HEIERMAN - HISTORIC LANDMARK COMMISSION REVIEW

05 October 2022

The Heierman Building

Re: Recorded Texas Historic Landmark project review, Heierman Building, 115 E. 5th Street, Austin, Travis County, Texas (RTHL 14733)

Michael Hsu Office of Architecture Street Facade Sight Line Study

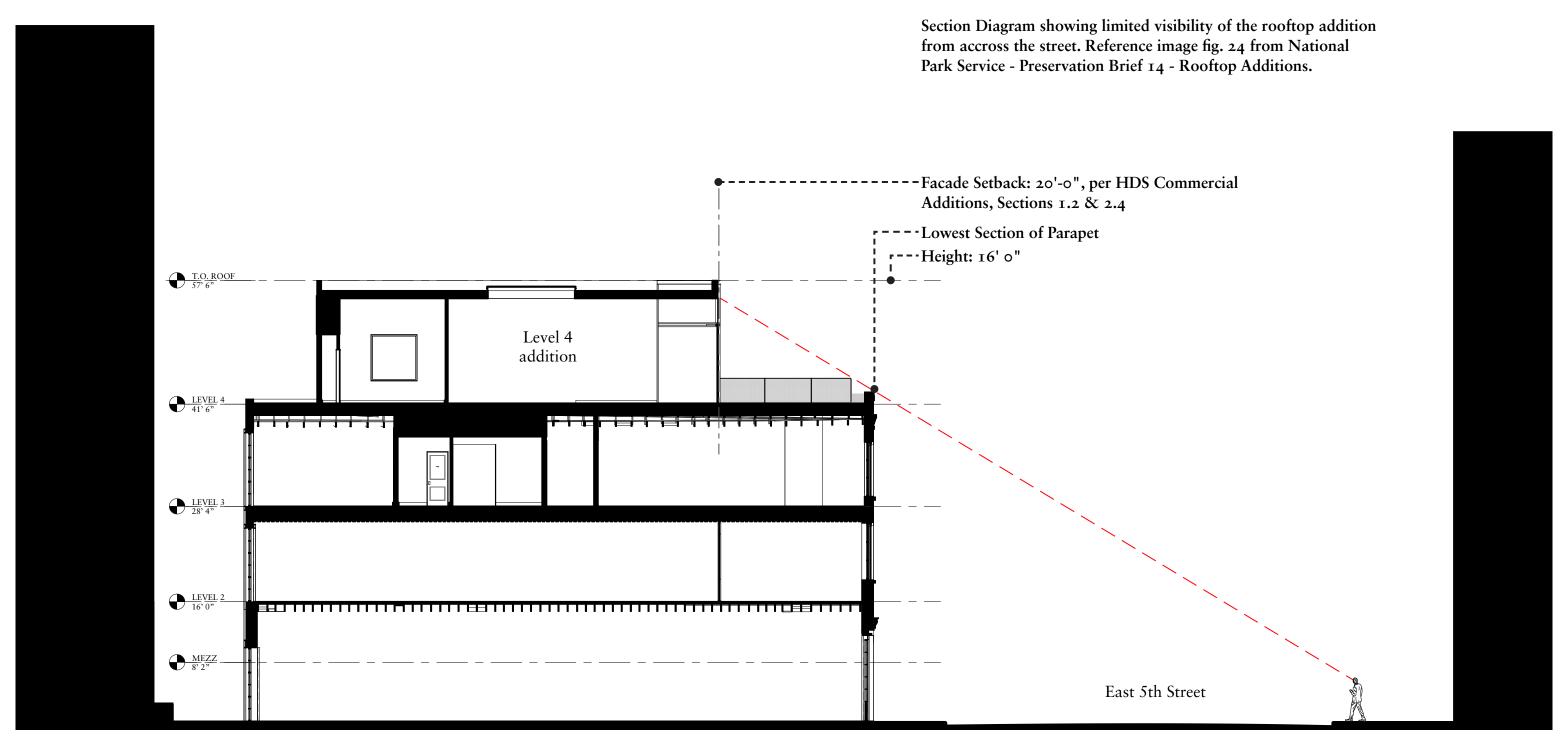
Regarding the proposed rooftop addition, our staff appreciates the architect providing the sight line diagram and accordingly setting the associated new construction twenty feet back from the primary façade's parapet to reduce visibility of the new addition from the principal perspective across 5th Street. Yet, our staff recommends the new addition being lowered in height to be more commensurate to the approximately 12'-13' heights of the historic second and third stories of the building. Furthermore, our staff recommends and expects the proposed steel paneling of the new addition to be painted a lighter color to blend in more with the existing buff colored historic brick of the Heierman Building and the light grey concrete color of the parking garage directly behind the building to the south.

Street Facade Elevations

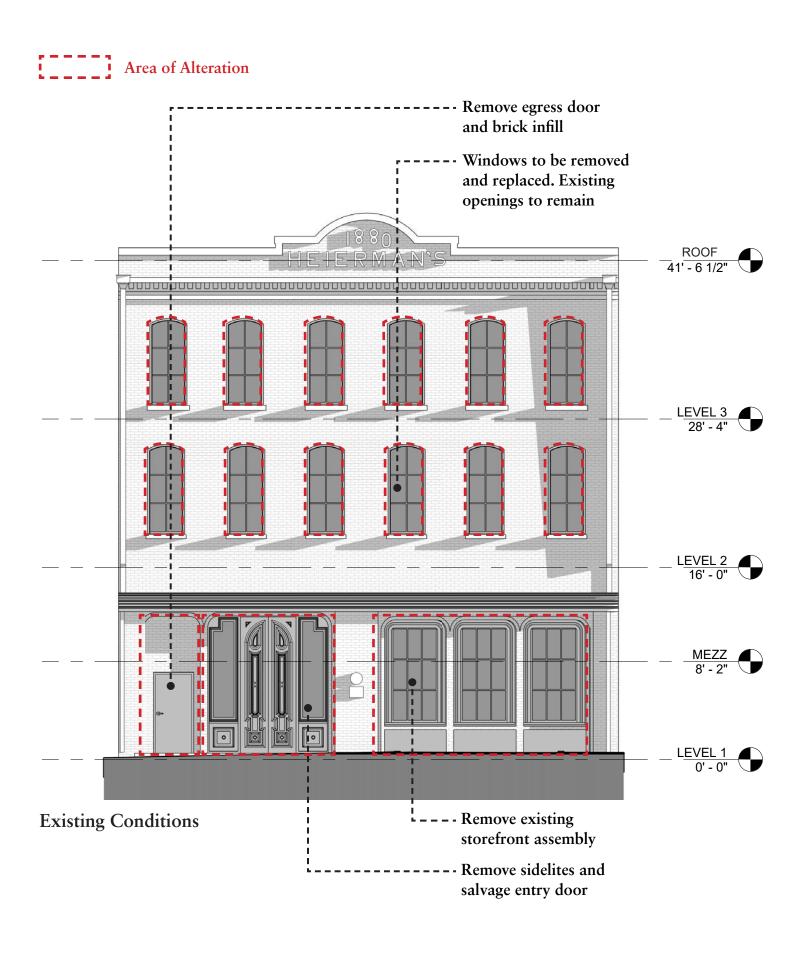
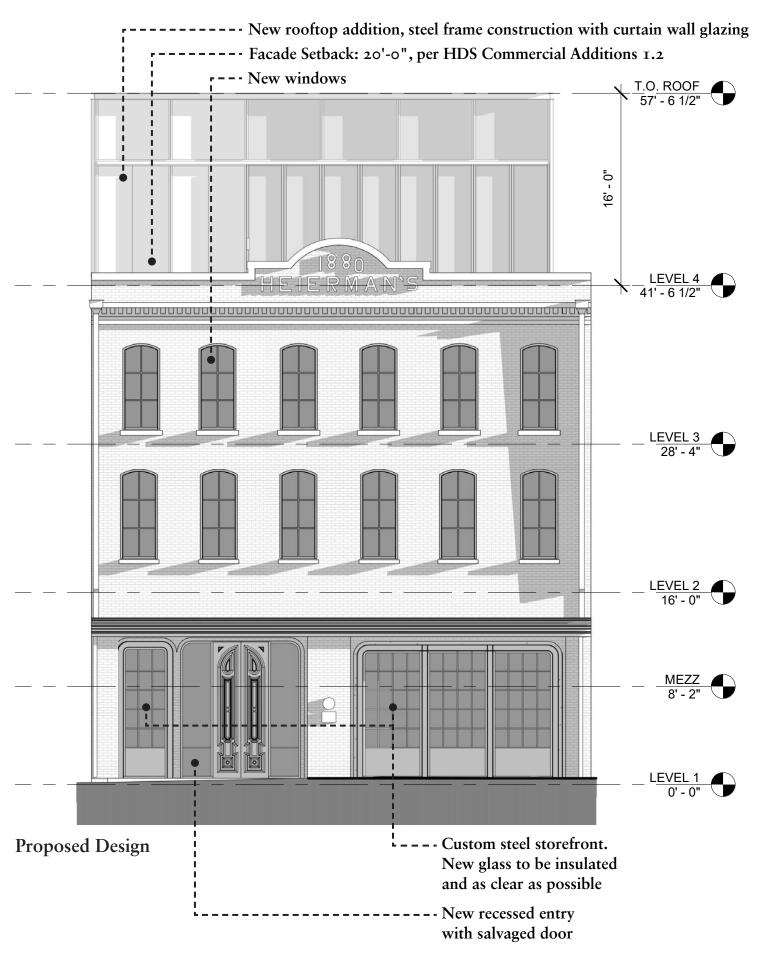
Furthermore, although the 1974 appearance of the building was referenced as a rationale for the proposed inset reconfiguration of the primary façade, the architectural condition of that portion of building had already been significantly altered and would not be considered historically significant, despite the Recorded Texas Historic Landmark designation having been awarded at that time. Similarly, the planned alterations to the rear, south elevation are not a recommended approach due to the extensive removal of original historic brick masonry and original fenestration openings that is proposed. Yet, due to the severity of inappropriate changes to the building over time, along with the most extensive alterations proposed being on the rear elevation and therefore not visible to the public, our staff will not be making a recommendation to pursue removal of the RTHL designation in the case that the current design plans are carried out. Our staff does recommend salvaging and storing (for potential future reuse), as much of the historic material planned for removal as possible.
